Access Compliance Report

Public Rights-of-Way

Intersection ID: 14213	Main Street: CENTRAL_AV	Cross Street: ROSEHAVEN_DR	Location: NE
ADA ID: E9C7836BC1B5	Ramp Type: Para	Initial Pass/Fail: Pass	Overall Compliance: No
		Severity Score: 2.75

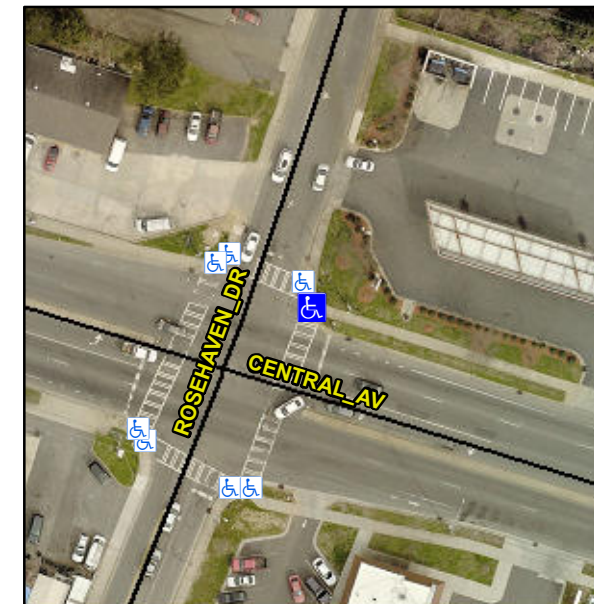
LT RP < 5%

Not Found, R304.5.3, R304.2.1, R304.2.2-Perp, R304.3.2-Para, R305.1.4

Compliance	Description	Data	Compliance	Description	Data
N/A	Ramp Length LT (in)	40.0	N/A	Ramp Length RT (in)	51.0
Yes	Ramp Width LT (in)	75.0	Yes	Ramp Width RT (in)	75.0
Yes	Ramp Slope LT (%)	0.4	Yes	Ramp Slope RT (%)	5.6
No	Ramp XSlope LT (%)	4.0	Yes	Ramp XSlope RT (%)	1.9
Yes	Landing Length (in)	85.5	Yes	DWS Provided?	Yes
No	Landing Width (in)	34.0	Yes	DWS Contrast?	Yes
No	Landing Slope (%)	3.3	Yes	DWS Length (in)	28.0
No	Landing X Slope (%)	2.6	No	DWS Full Width?	No
N/A	Landing Curb? (Y/N)	No	Yes	DWS Offset (in)	2.0
N/A	Shared Landing?	No			
Yes	Gutter Ponding?	No	Yes	Gutter Slope (%)	0.5
Yes	Gutter Lip Ht (in)	0.0	Yes	Gutter X Slope (%)	0.2
N/A	Painted X Walk1?	Yes	N/A	Painted X Walk2?	N/A
	X Walk 1 Direction	To S		X Walk 2 Direction	N/A
N/A	X Walk 1 Width (in)	111.0	N/A	X Walk 2 Width (in)	N/A
	X Walk 1 Slope (%)	2.4		X Walk 2 Slope (%)	N/A
	X Walk 1 X Slope (%)	1.0		X Walk 2 X Slope (%)	N/A
Yes	Ramp inside XWalk1?	Yes	N/A	Ramp inside XWalk2?	N/A

Remove & Replace Entire Ramp.
